**Edwin I. Hatch Nuclear Plant
Request for License Amendment
Extended Power Uprate Operation**

Page Change Instructions

The proposed changes to the Plant Hatch Unit 1 and Unit 2 Facility Operating Licenses and Technical Specifications are incorporated as follows:

**Facility Operating License Proposed Change
and
Technical Specifications Proposed Changes**

DELETE - SEE PROPOSED FIGURE ATTACHED,
Figure 3.4.9-3 (page 1 of 1)
Pressure/Temperature Limits for Criticality

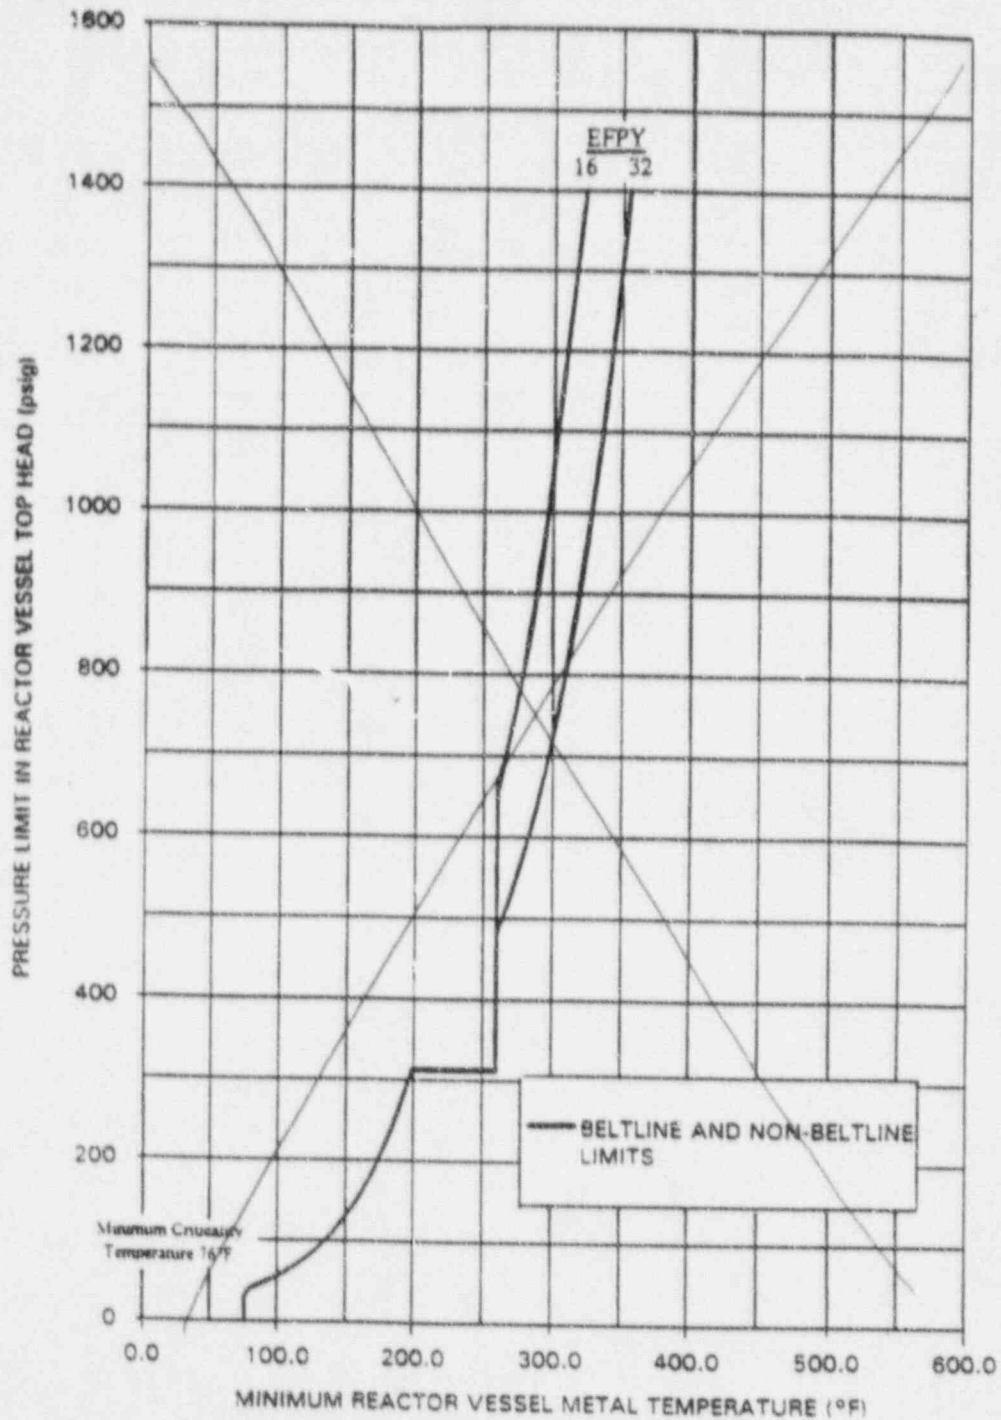
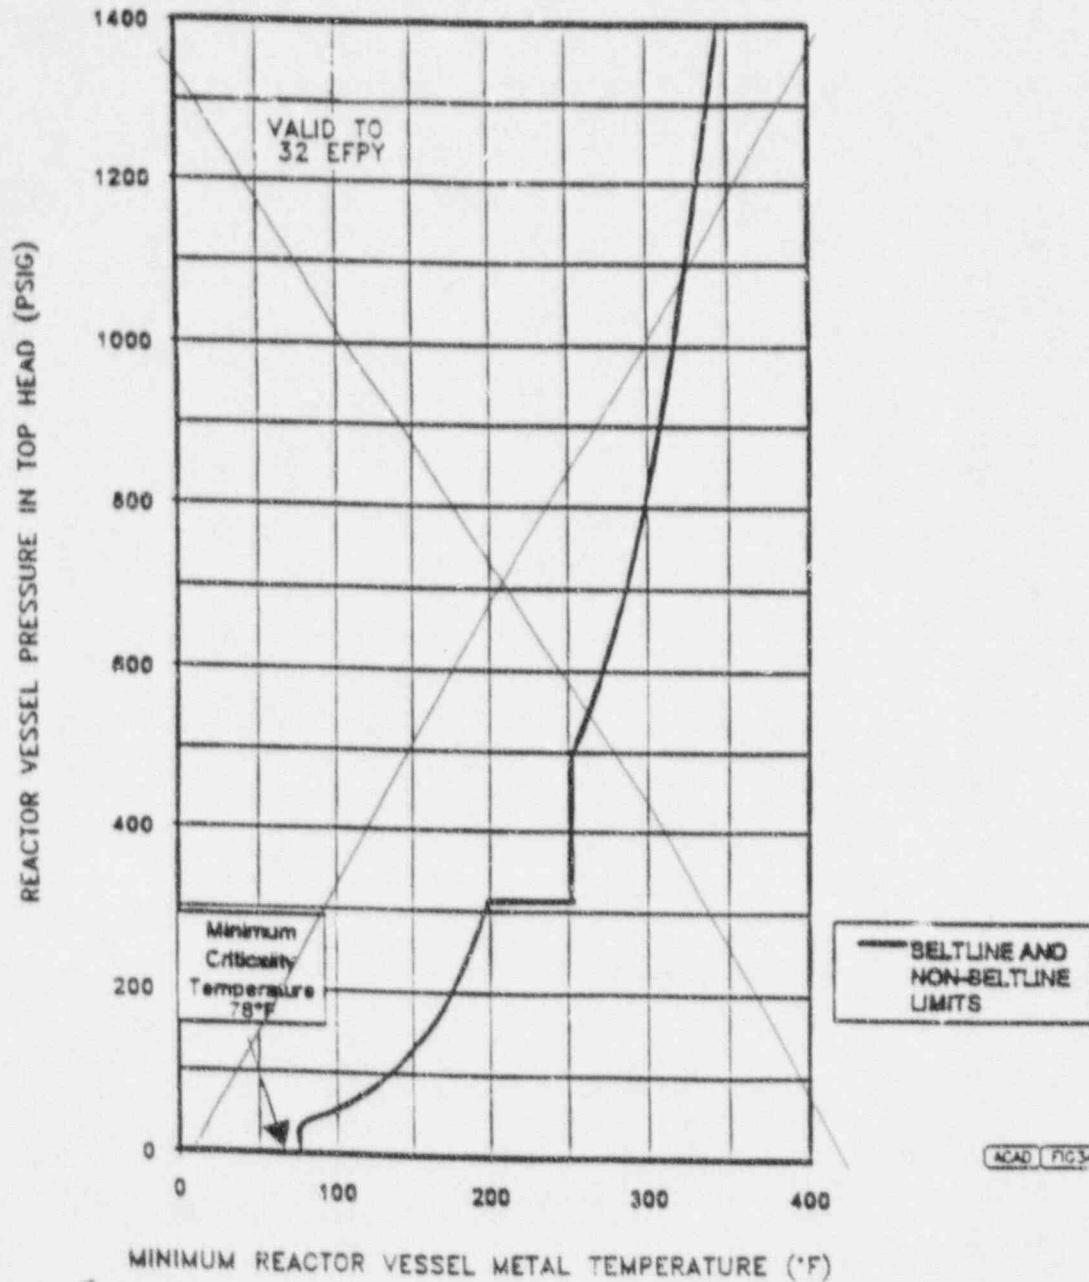
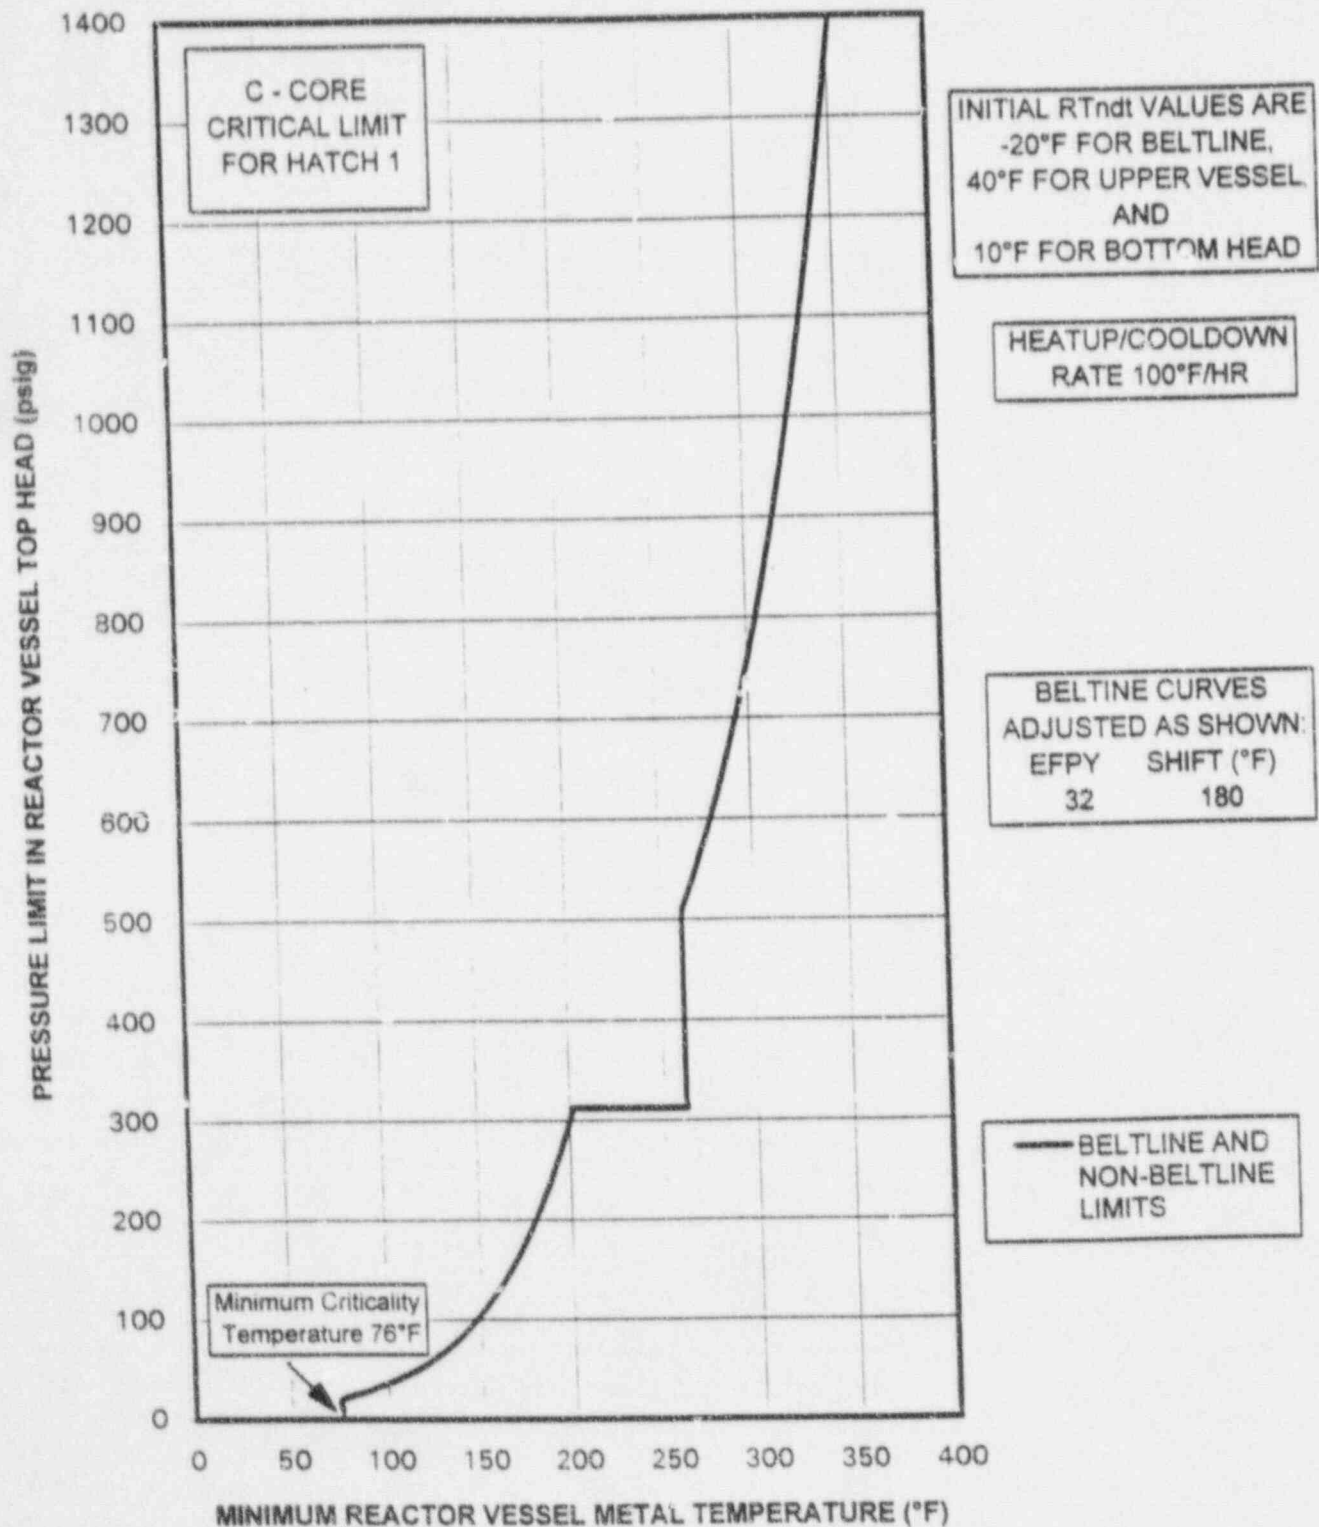
REPLACE WITH ATTACHED CURVE.

Proposed Figure

Figure 3.4.9-3 (Page 1 of 1)
Pressure/Temperature Limits for Criticality

Figure 3.4.9-1 (page 1 of 1)
Pressure/Temperature Limits for
Inservice Hydrostatic and Inservice Leakage Tests

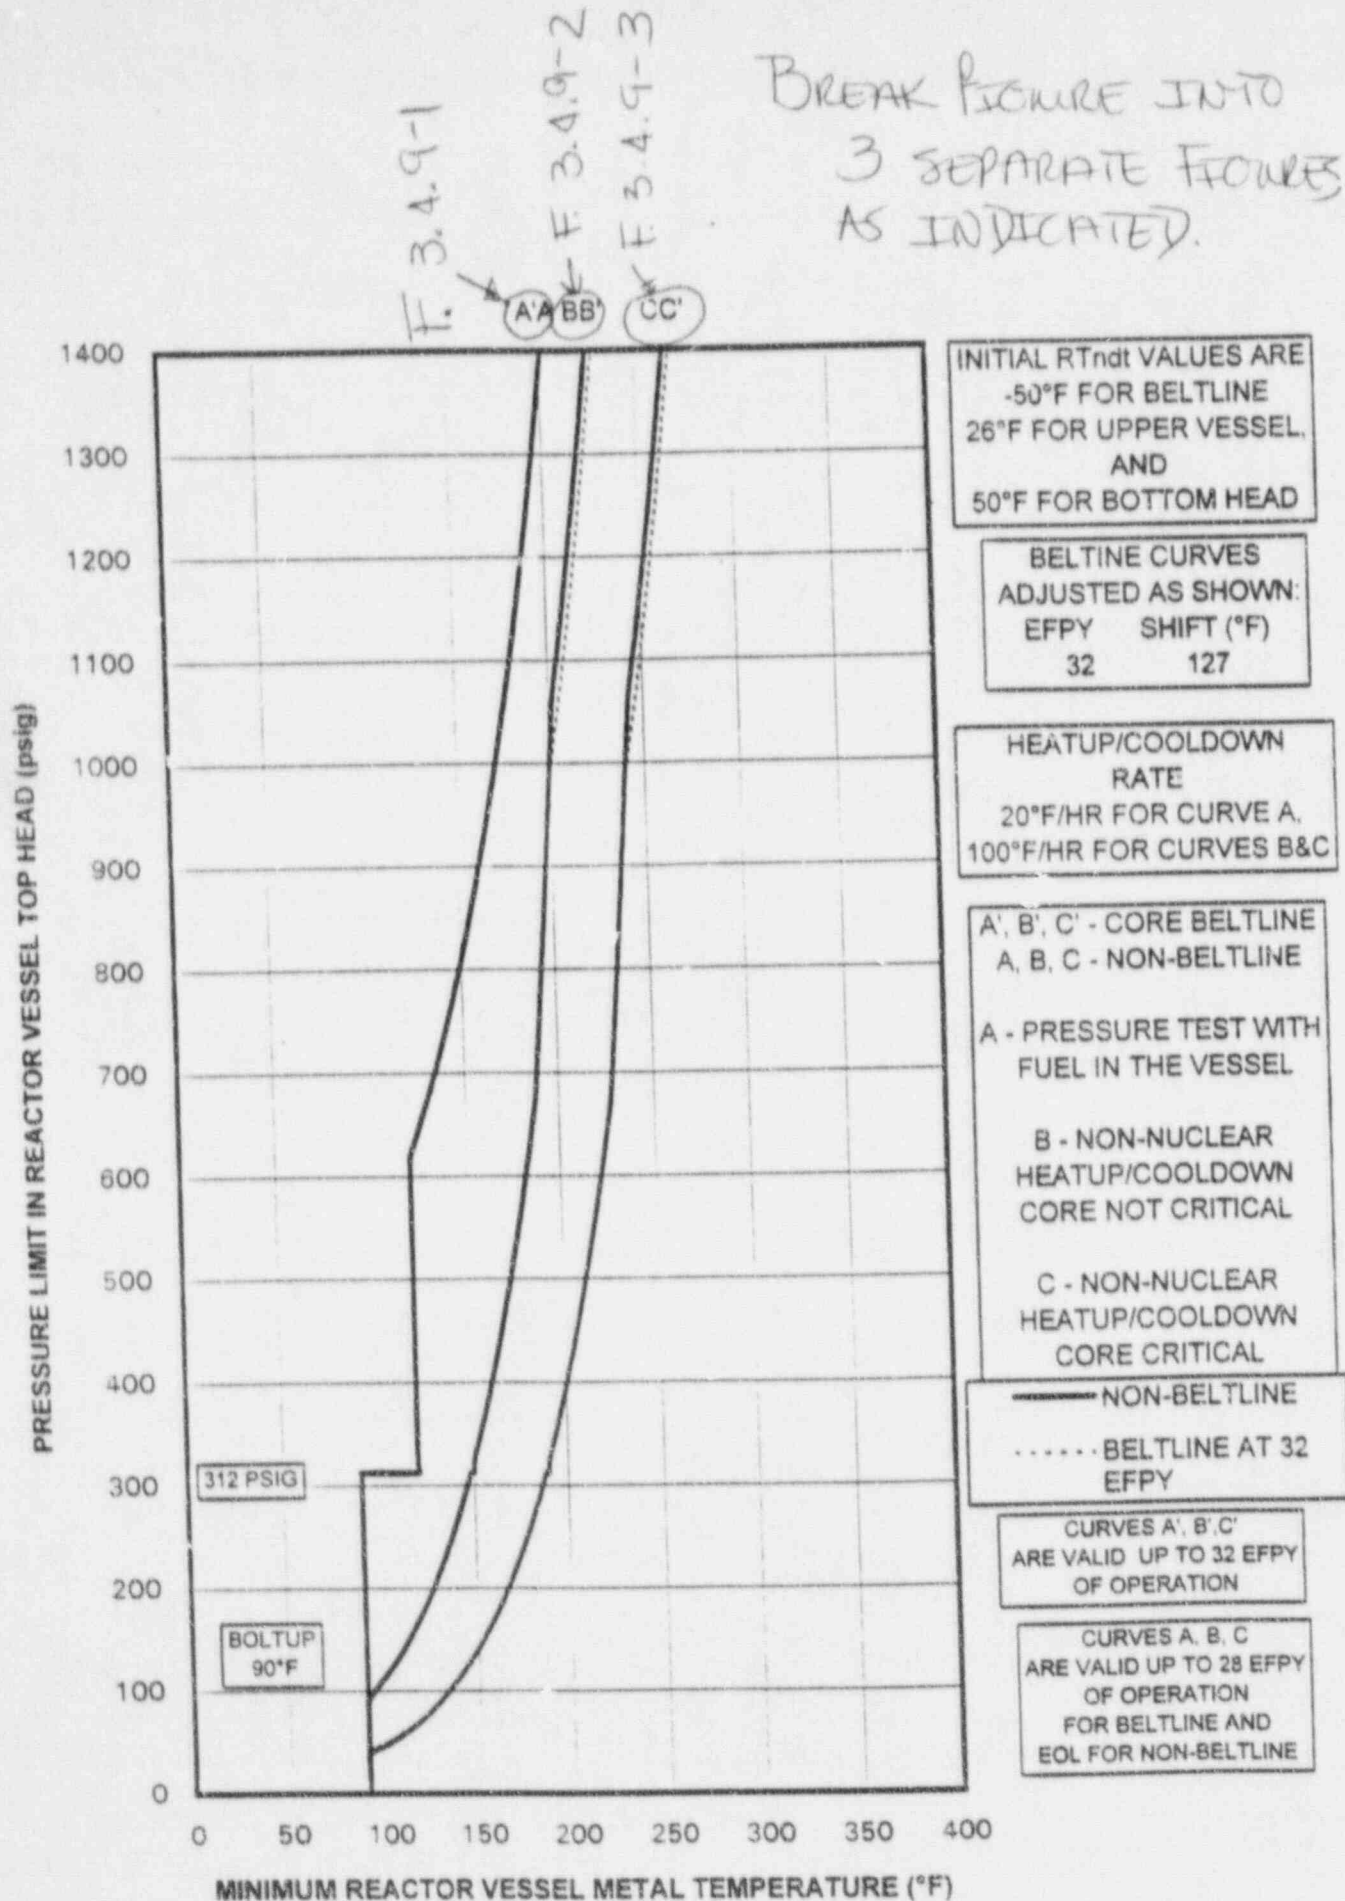
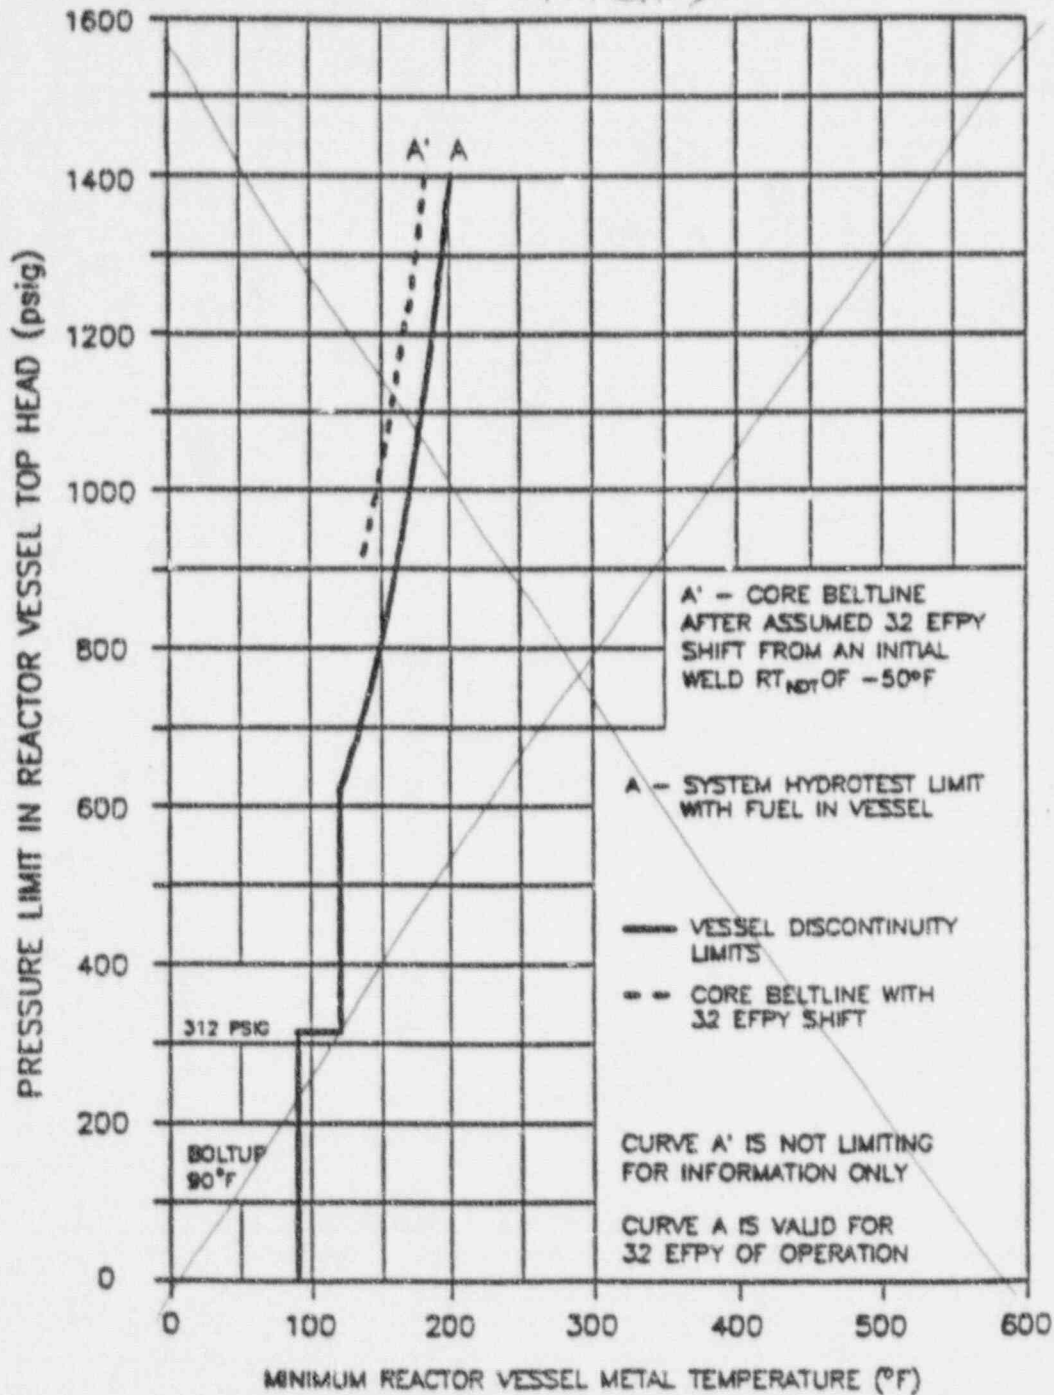
REPLACE WITH A'A CURVE ATTACHED.

Figure 3.4.9-2 (page 1 of 1)
Pressure/Temperature Limits for Non-Nuclear Heatup,
Low Power Physics Tests, and Cooldown Following a Shutdown

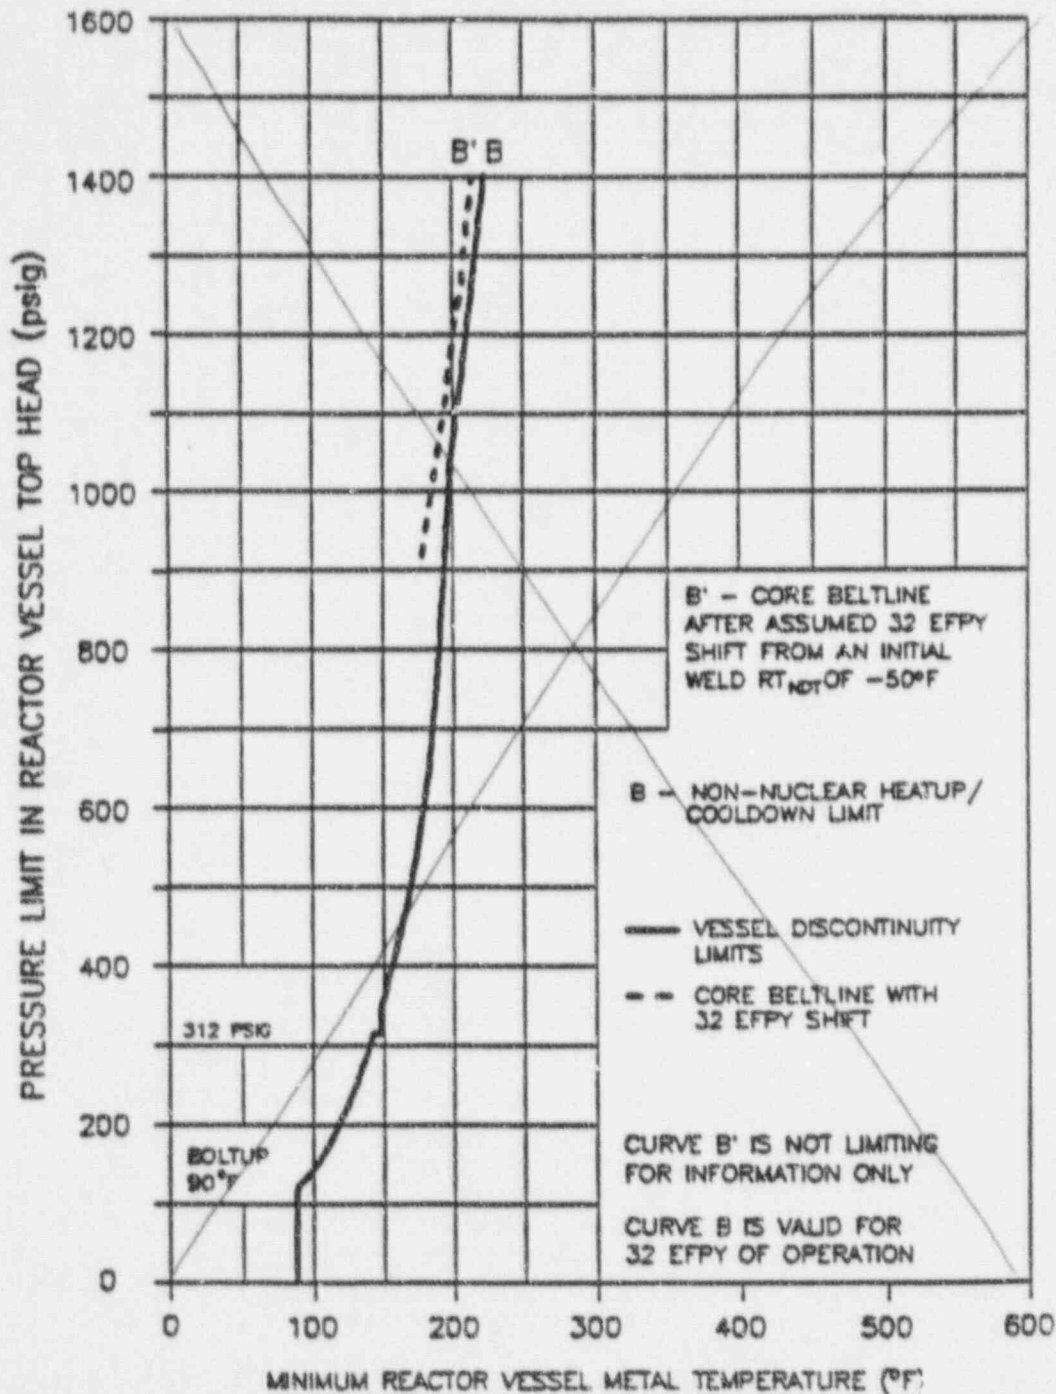
REPAIR WITH B'B CURVE ATTACHED.
